Groundwater Transfer Review Summary Form

Transfer/PA # T- 14384

GW Reviewer James Hootsmans/Travis Brown Date Review Completed: 11/1/2024

Well Location Map

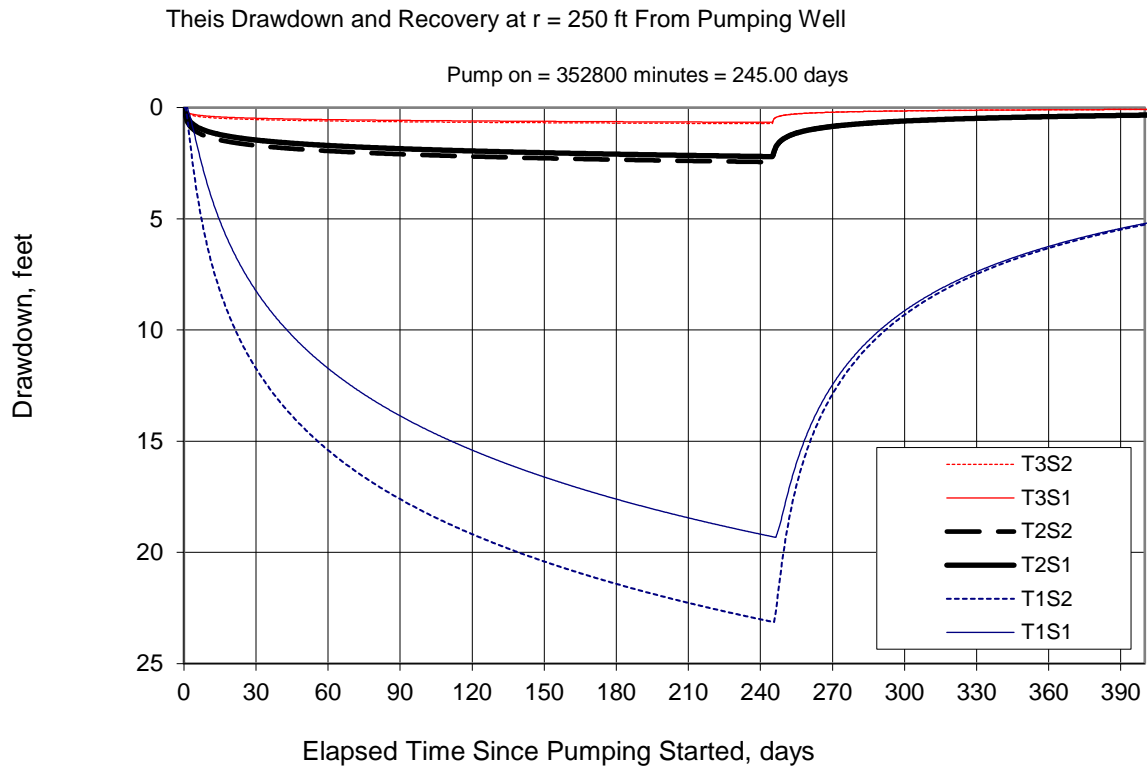
4. a) Will this proposed change, at its maximum allowed rate of use, likely result in an increase in interference with **another ground water right**?
 Yes No Comments: The proposed To-POA is closer to neighboring water right POA 2 on Certificate 26891 (also POA 1 on Certificate 54829) compared to the existing POA; therefore, the proposed change will likely result in an increase in interference.

- b) If yes, would this proposed change, at its maximum allowed rate of use, likely result in another groundwater right not receiving the water to which it is legally entitled?
 Yes No If yes, explain: The proposed To-POA is ~250 ft from the presumed location of POA 2 on Certificate 26891, rather than ~890 ft like the From-POA. Permit G-216 (which became Certificate 26891) noted POA 2 as 25 ft deep, with the depth to water estimated at 10 ft. Total depth of the Willamette Aquifer in this area is estimated at 60-80 ft, resulting in an estimated saturated thickness of 50-70 ft (Gannett & Caldwell, 1998; Woodward et al., 1998). The potential interference with neighboring POA 2 resulting from the proposed change was estimated using the Theis (1935) solution (see attached Well Interference Analysis). Results of the analysis indicate the proposed change is not likely to result in injury of the neighboring POA 2.
